CITY RESUBMISSION BOOKLET

DECEMBER 1, 2025

REDESIGN OVERVIEW

267 O'CONNOR OTTAWA, ON DRAWING TITLE:

REDESIGN OVERVIEW_ **HERITAGE PODIUM**

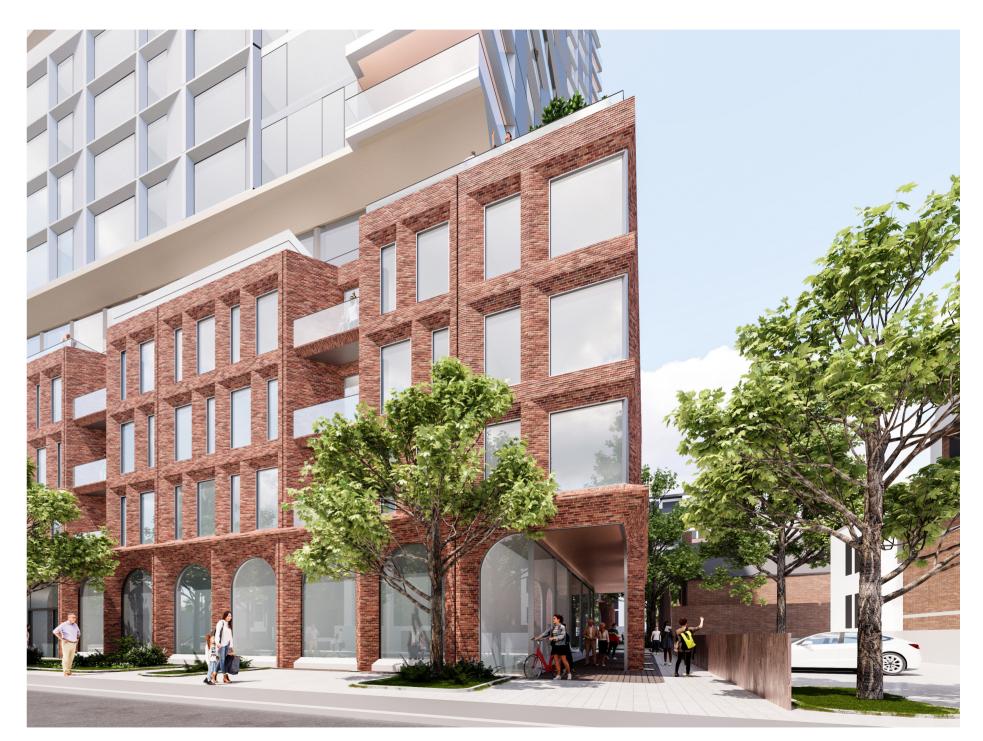
- Heritage Podium has extended the red masonry to the lower level.

REDESIGN OVERVIEW_ POPS

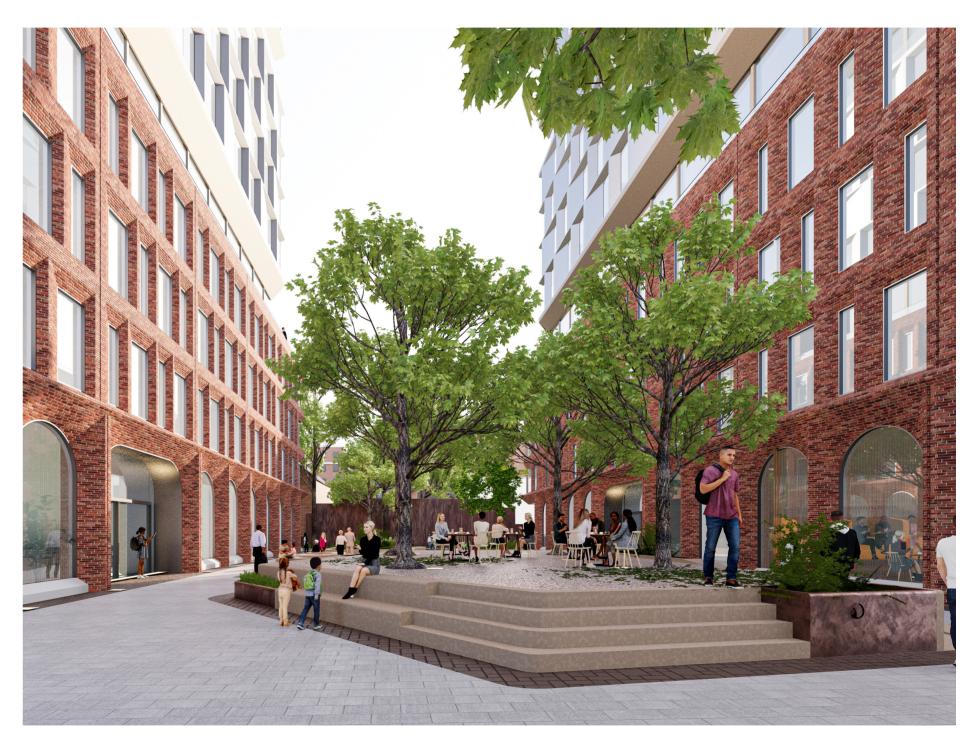
- Redesign of the landscape strategy by moving the elevated gathering feature closer to O'Connor.
- Overall improvement of flow and circulation by refining the locations and angles of planters and paths.

REDESIGN OVERVIEW_ TOWER

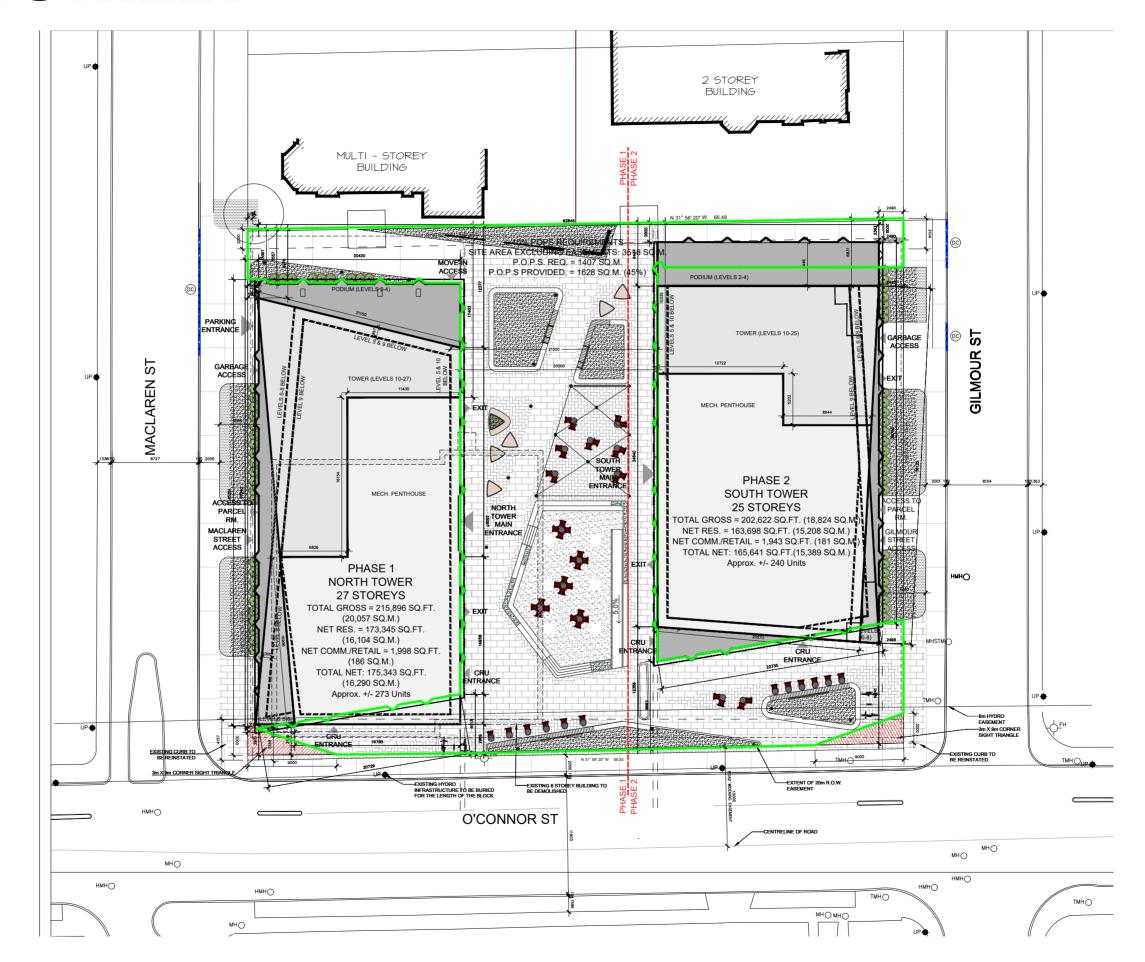
- Refinement of North and South tower elevations to break down the scale of the long edge. A simplified facade module has been introduced towards the eastern end.
- Refinement of roof and canopy into a larger exterior space with sloping canopy relating to the transition of the north/south facades.
- Articulation of balconies through the materiality. A proposed warm tone stone or metal is used on the underside and the inner wall of the balcony creating a smooth transition to the canopy of the roof.
